NABCO ENTRANCES TECHNICAL BULLETIN

Modification for Radio Controlled Transmitters

Bulletin Number: **14**

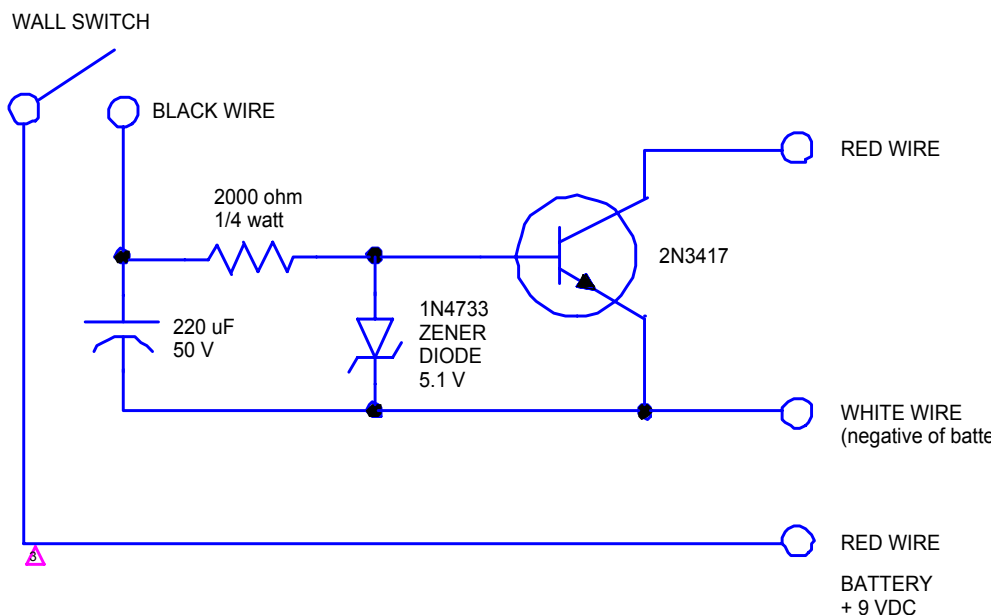
We have received reports of pulse extender boards having weak signals. As a result, they were not picked up by the receiver.

To strengthen the signal:

1. Remove the RED wire from the switch going to the pulse extender board.
2. Cut this wire off at the board.
3. Solder a wire onto the radio controlled transmitter board where the red battery wire is soldered.
4. Attach the other end of this wire to the switch.
